June 2022

Maintenance Building Revised Design Report S4.55 Mod 1 Application

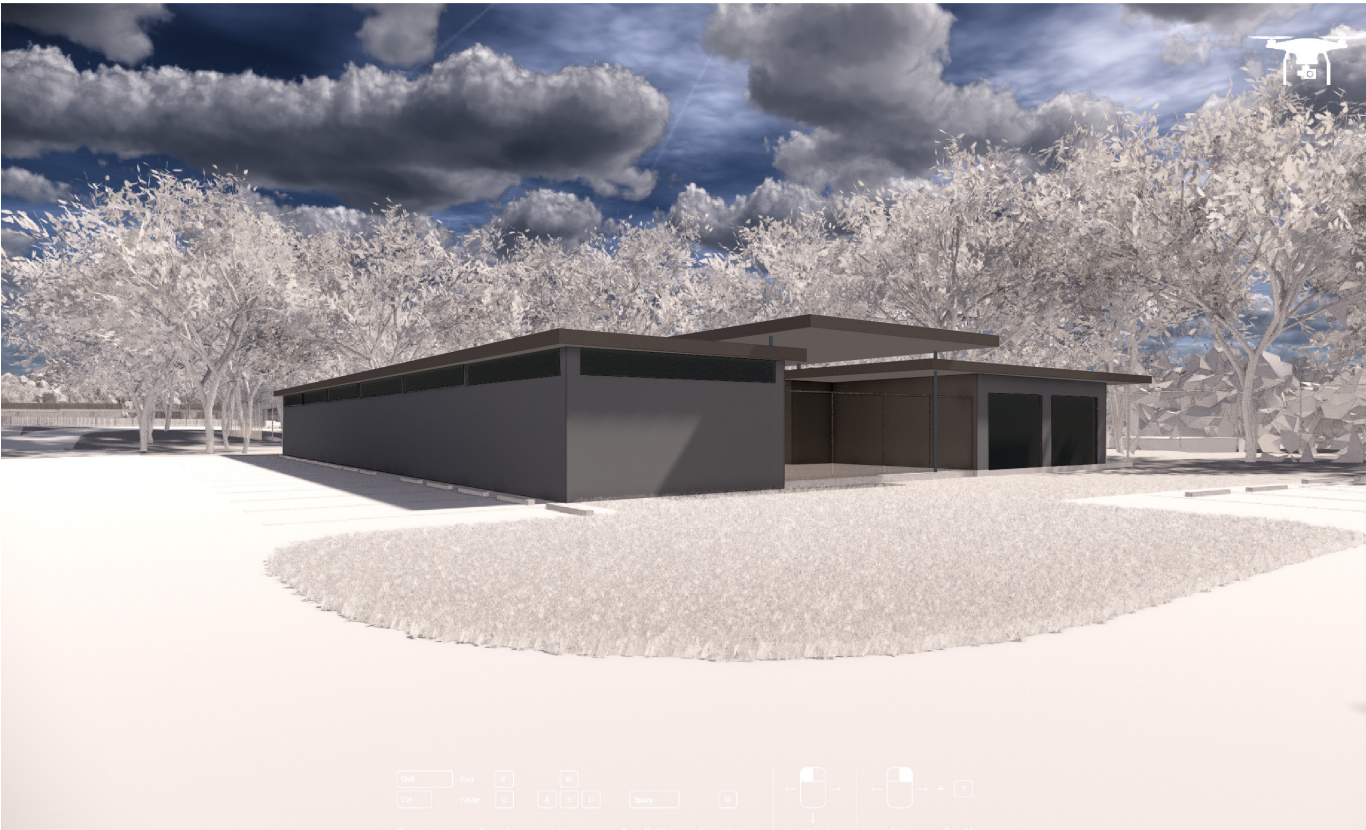
The resulting form of the maintenance building (figure 2,) is more in-line with the external forms of the buildings comprising the cafe, indoor training and administration components that make up the main building, which are all in essence an extruded form with a one way sloping roof, where the previous design (figure1,) had an independent expression separate from the other buildings.

Figure 3 Site plan overlay on 1961 Gas Works

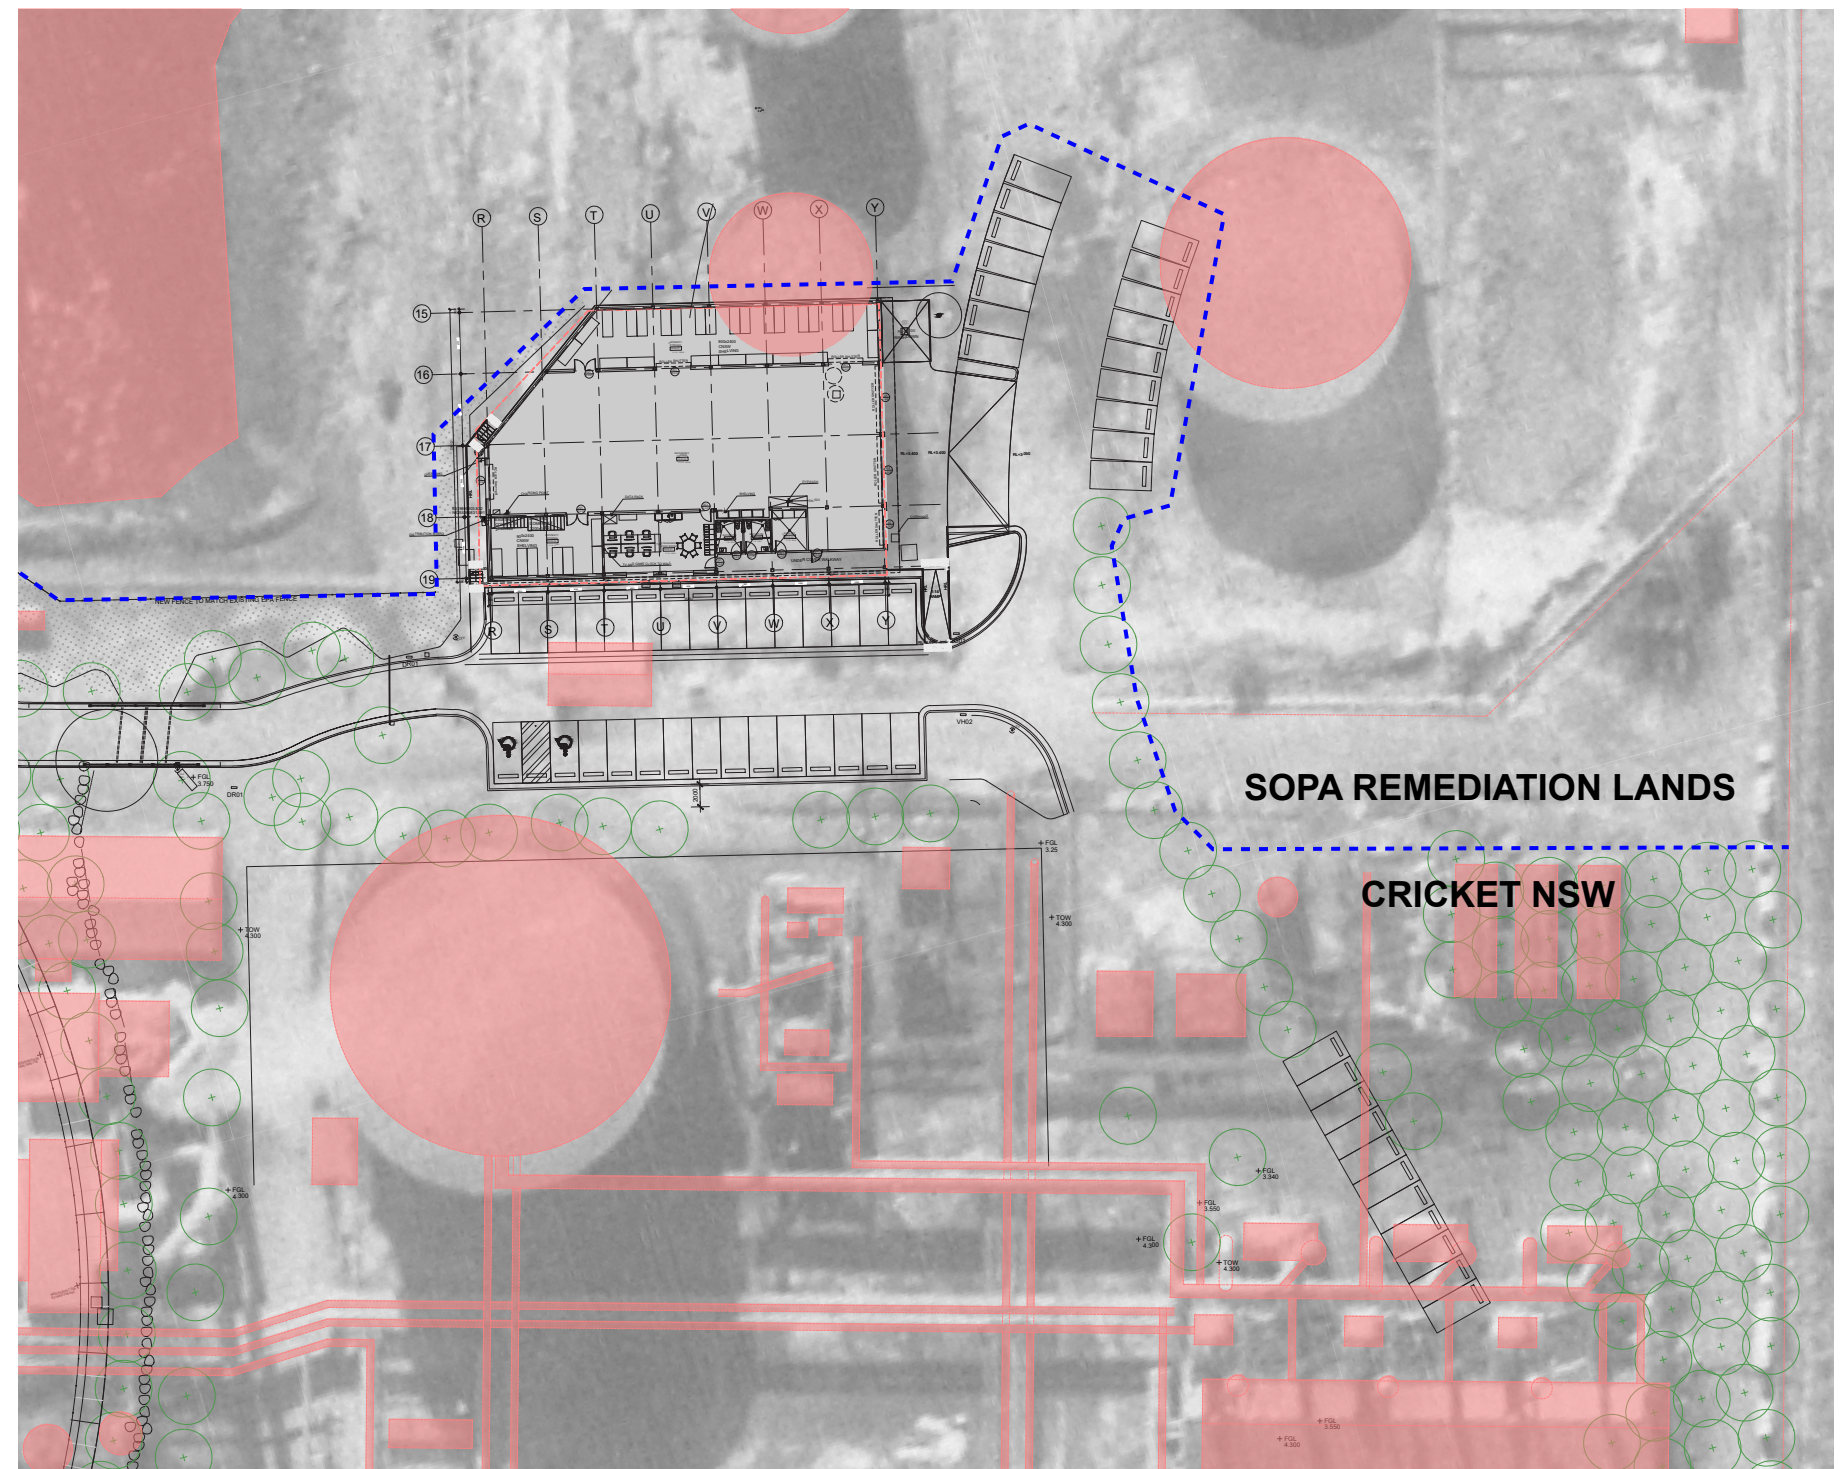
The maintenance building located within the site boundary of the Cricket NSW centre of excellence has been modified to develop a lighter weight structure, which has been located at a slightly higher level (+200mm from previous design,) due to the highly contaminated ground conditions encountered within the vicinity of the building during early works investigations. (Figure 3)

The demolition of the existing toilet block as part of this modified design, has also allowed for the inclusion of a gas membrane to be located below the slab of the new maintenance building. This gas membrane has been included under all of the buildings constructed as part of the Cricket NSW project. This provides significant improvements to the internal environment of the modified design, where previously there was doubt regarding the efficacy of the slab under the existing toilet block.

Figure 5 Diagram of planning revisions by functional area

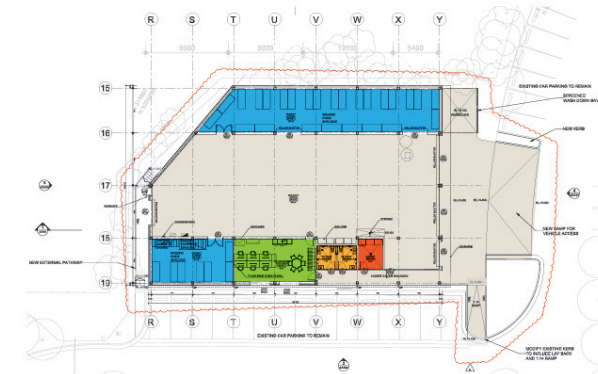
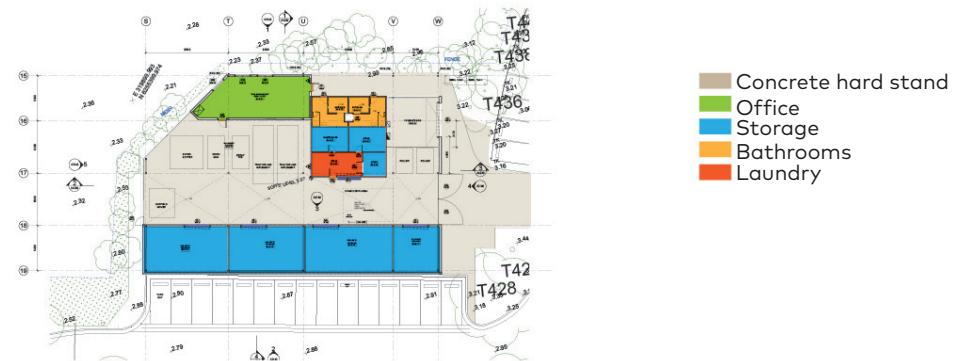
The building also contains the long-term storage for Cricket NSW and cover and workshop for groundskeepers vehicles required to maintain the many fields and wickets incorporated into the precinct's design. (Figure 5.)

This option has resulted in many positive outcomes from the revised planning. Primarily the inclusion of better internal circulation for vehicles for both grounds keeping and storage. The internal planning has also moved the wash down bay externally so it doesn't impede the internal circulation. The combination of these two design changes allows for long term adaptability of this building.

The other positive outcome with the removal of the existing toilet block has allowed an improved location for the public amenities and associated office. This modified planning has essentially flipped the previous design, resulting in a more efficient and legible building design that provides a superior CPTED outcome for passive surveillance from public open areas. The improved legibility in the building design also allows the building to not rely on signage to direct the public to the toilets on the occasions when these toilets will be publicly accessible (i.e. during public events and activations at the community cricket oval).

Figure 6 Diagram of pedestrian and vehicle movement

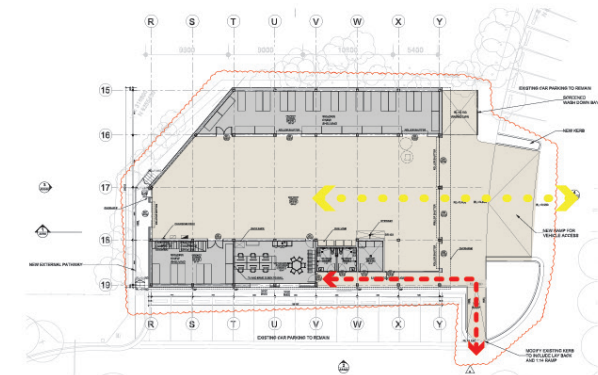
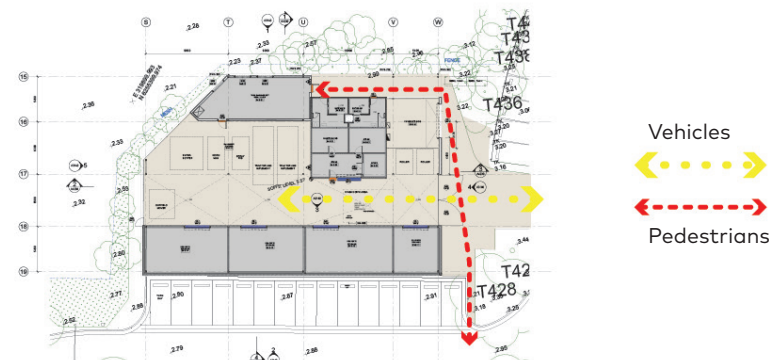
(Figure 6,) illustrates that the modified design separates the circulation of pedestrians and vehicles whereas they previously had to cross the main access way but they are now two discrete paths of travel. As such, this provides an improved safety outcome which is further enhanced by the incorporation of the Traffic Management Plan prepared by Traffix.

Figure 7 Approved elevation in red overlaid on the proposed elevation

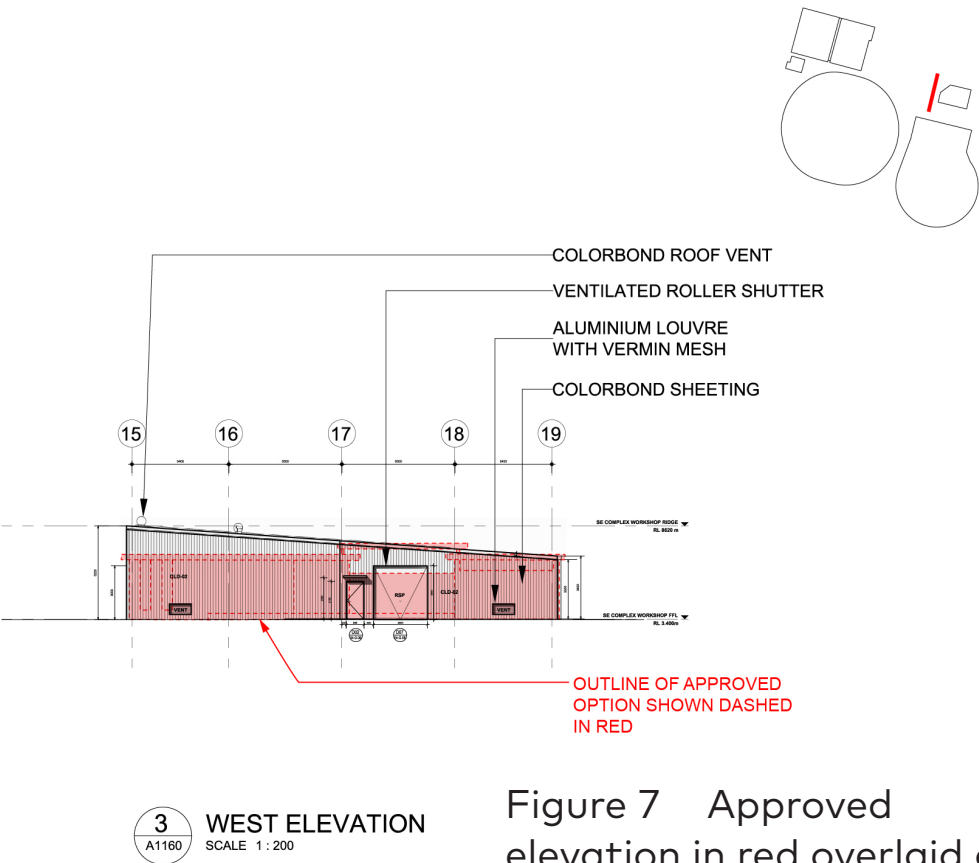
The western elevation is similar to the previously approved elevation, although it is flipped on its axis, comprising a large roller shutter which can be opened or closed depending on the weather, replacing the mesh gate in the approved design. Compared with the approved scheme, the proposed modified design promotes controlled cross ventilation of the building through the roller shutter door and also conceals a lot of the clutter of the maintenance equipment within the building which was left exposed in the approved design due to the mesh used in the wall of the elevation.

Figure 8 Approved elevation in red overlaid on the proposed elevation

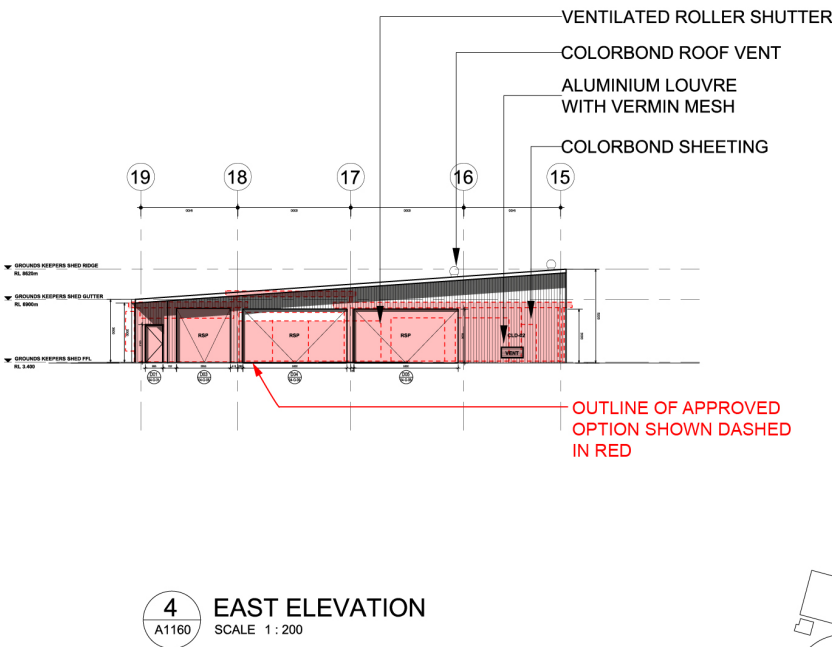
The eastern elevation address the eastern car park and is the main vehicular entry and exit point for both maintenance vehicles and vehicles accessing the long term storage area for Cricket NSW. The previously approved planning option required a central circulation spine due to having to plan around the existing toilet block. The proposed option has a lot more flexibility in this internal planning so as a result has more operable roller shutters to this elevation to gain access and promote cross ventilation. The eastern elevation has a 1 metre cantilever to the roof edge to provide some weather protection to this entry.

The external wash down bay is located externally on this elevation refer to section 2.3 for more information on this element.

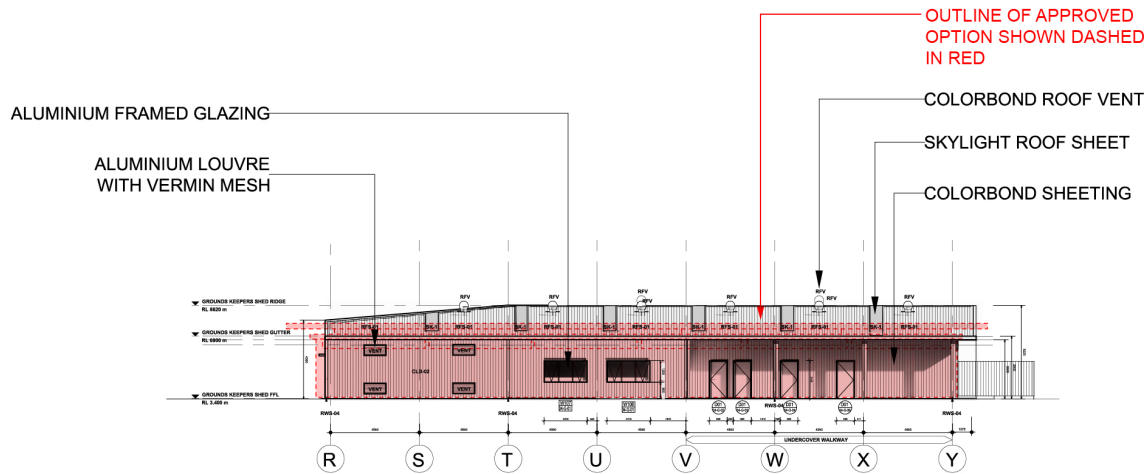
The proposed modified south elevation activates the south of the building that faces the southern car parking area, as it includes doorways to the maintenance building, the groundskeepers office, laundry area and the bathrooms. The approved southern elevation is the tallest blank wall of the building (4390mm), with high level vents in it. The proposed modified design is the lowest overall wall (3500mm), giving better sun amenity into the car parked situated to the south. The activation of the southern facade of the building will also improve the passive surveillance of the southern car parking area which will significantly improve CPTED outcomes.

There are additional safety benefits to this planning change as people using the bathrooms are no longer required to cross the active entrance to the vehicle storage. The office and public bathrooms facing this elevation are now identifiable from the public area where the previous option primarily relied on signage to direct people to the rear side of the building which is not a preferable outcome. The revised planning provides bathrooms of a larger size which can also be adapted as parents' rooms or can accommodate parents and young children in attendance of the development for major events or activations at the community cricket oval.

Figure 9 Approved elevation in red overlaid on the proposed elevation

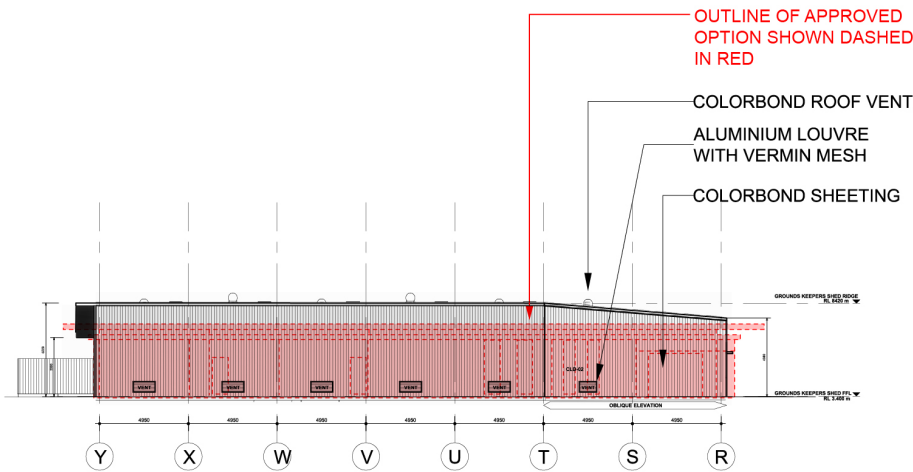
The Northern elevation in the proposed design is now a tall blank wall with low level louvres in it. This should be noted that it is not a public facing wall as it looks onto the fence securing the mounds and ponds of the contaminated lands beyond, so in essence the building has now turned its back on this contaminated area.

The approved plans for this elevation was the rear corridor to gain access in the modified bathroom entries and to the groundskeepers office. This outcome was not a preferred option but was driven by the building's relationship with the existing amenities block, resulting in a potentially undesirable security outcome. Therefore, as noted above, the relocation of the entry points from the north to the southern elevation has resulted in an improved safety outcome.

Figure 12 Diagram of oil separator

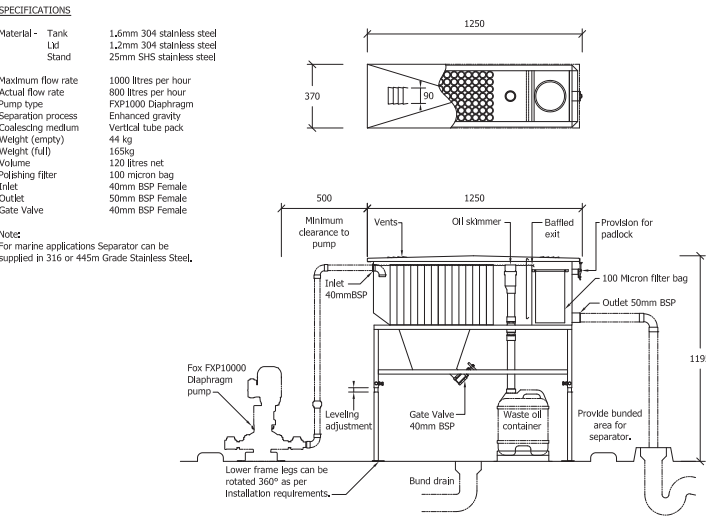
The wash down bay itself consists of a bunded area with falls to a central gross pollutant trap with a silt basket, acting as a primary separator to remove large particles such as grass clippings. This then flows by gravity to a retention pump out pit which is in turn pumped out to an above ground oil separator. The oil separator traps the oil on top of the water via a series of baffles allowing it to be "trapped" and removed whilst clean water is removed via another pipe to flow to the sewer. (Figure 12)

Figure 13 Arborist report

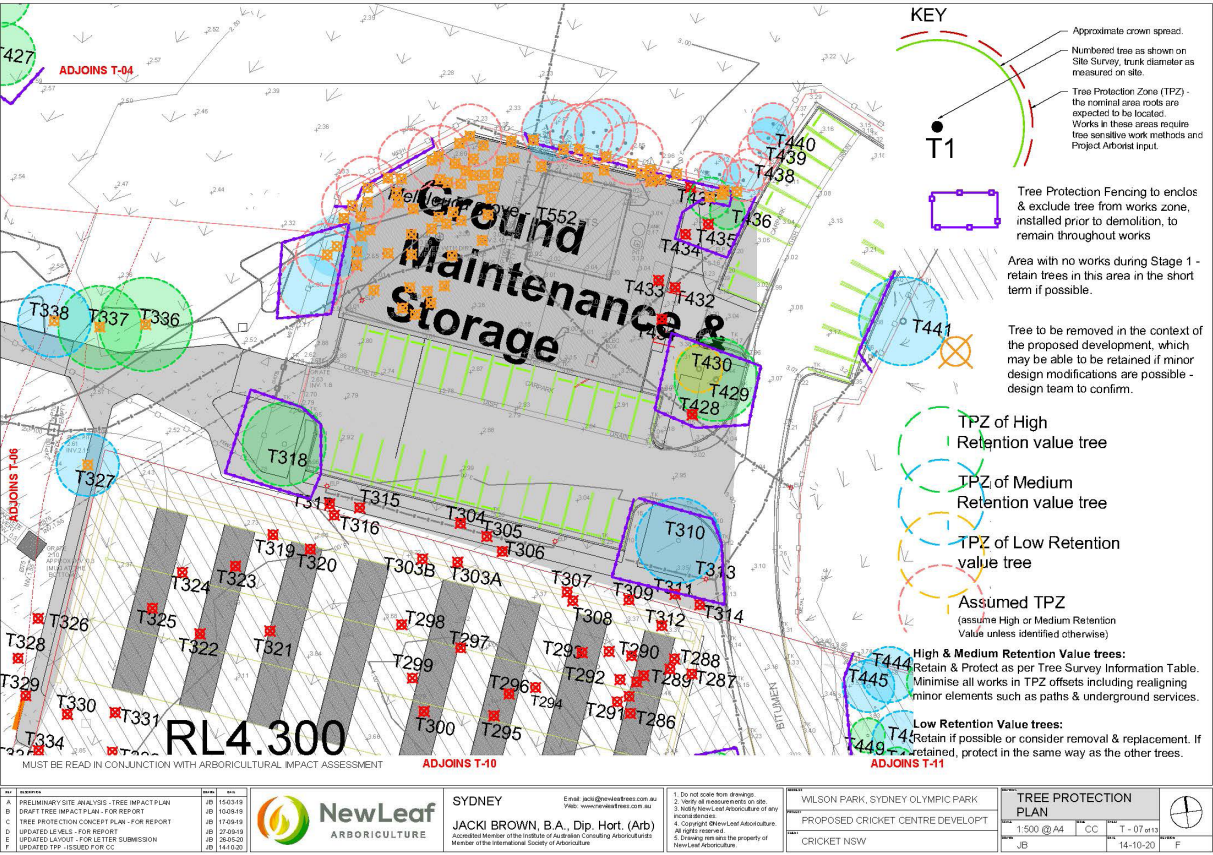
With the relocation of the wash down bay, the removal of a single tree is required. (Figure 11) This tree is noted in the arborist report as a tree that can be removed in the context of the development. The tree is identified as number 437 in the arborist report, noted as a Corymbia citriodora - Lemon-Scented Gum and is listed as a semi mature tree of high retention value in good or average health, it is of moderate significance.

The adjacent tree 436 has been preserved as part of this revised development, it is a tree of the similar type and attributes as tree 437 (Figure 13)
